REQUEST

Current Zoning: R-3 (single family residential)
 Proposed Zoning: UR-2(CD) (urban residential, conditional) with five-year vested rights.

SUMMARY OF PETITION

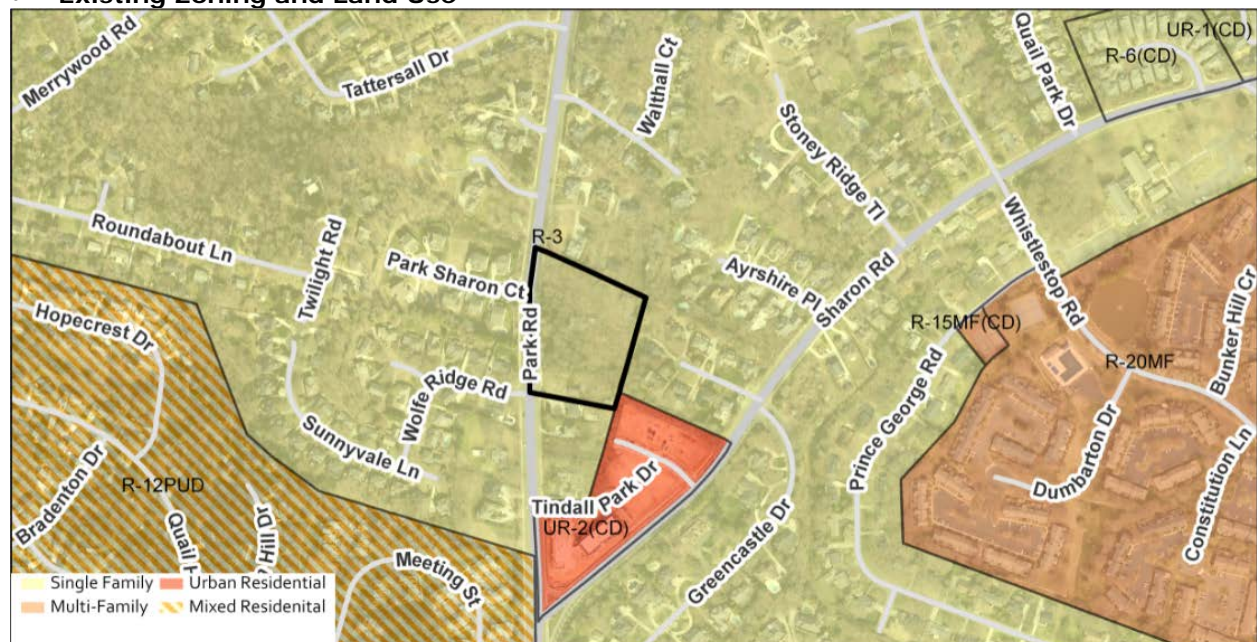
4. Revise the site plan and add a conditional note to show a minimum 16-foot planting strip. The

wide planting strip will accommodate a future buffered bike lane to be installed by others. The minimum width of the planting strip should be 16 feet measured from the existing back-of-curb except as indicated and noted that topography imposes a restriction. **Outstanding.** The petitioner notes that an eight-foot planting strip and six-foot sidewalk will be constructed as depicted on the site plan. The petitioner has asked for a plan that shows this future curb line. The petitioner states that their plan accommodates the development of such public facilities in the future and contains the eight-foot planting strip and six-foot sidewalk required by Ordinance.

5. Revise the site plan to add a note specifying dedication and fee simple conveyance of all rights of way to the City before the site's first building certificate of occupancy is issued. The right-of-way should be set 22-feet from the existing back of curb. Add a note stating, "The proposed six-foot sidewalk may meander and any portion of the sidewalk located outside of the right-of-way shall be located in a public access easement. The exact location will be reviewed, and approved by City staff during permitting." **Outstanding.** The petitioner added the following note: "If the existing right-of-way for Park Road does not meet ordinance standards the Petitioner will provide for the dedication and fee simple conveyance of the right of way for Park Road based on 50' from the centerline to the City before the site's first building certificate of occupancy is issued."

6. Revise the site plan to add a note specifying all transportation improvements will be approved and constructed before the site's first building certificate of occupancy is issued. The petitioner may phase transportation improvements if said improvements and phasing are explicitly described in site plan notes. **Addressed.** The petitioner added the following note: "If any are required, all transportation improvement to Park Road will be completed prior to the issuance of the first certificate of occupancy."

7. Add a note to the Transportation section of the development standards to specify the removal of the existing sidewalk with the installation of the new sidewalk. **Outstanding.** The petitioner states that the sidewalk is not on their site and will not be disrupted by the development. The petitioner says that such removal will have a significant impact on the trees at the front of the site. The City can remove their sidewalk at any time or during widening for future road improvements.

13. Amend the site plan to show the location of the future back of curb, to be installed by others, eight feet behind the existing back of curb. **Outstanding.** The petitioner has asked for an adopted plan that shows this future curb line.

15. Revise the site plan by labeling, and dimension the existing sidewalk to be removed, and the proposed sidewalk. **Outstanding.** The petitioner states that the sidewalk is not on their site and will not be disrupted by the development. The petitioner says that such removal will have a significant impact on the trees at the front of the site. The City can remove their sidewalk at any time or during widening for future road improvements.

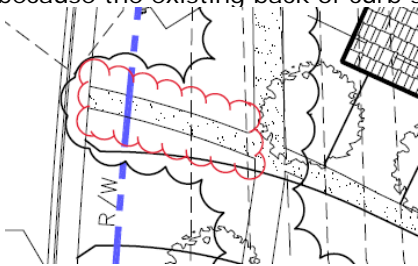
1. ~~Remove the section of internal sidewalk, shown below, that is parallel to the northern most driveway between the proposed sidewalk along Park Road and the existing back of curb sidewalk because the existing back of curb sidewalk should be removed.~~ Addressed
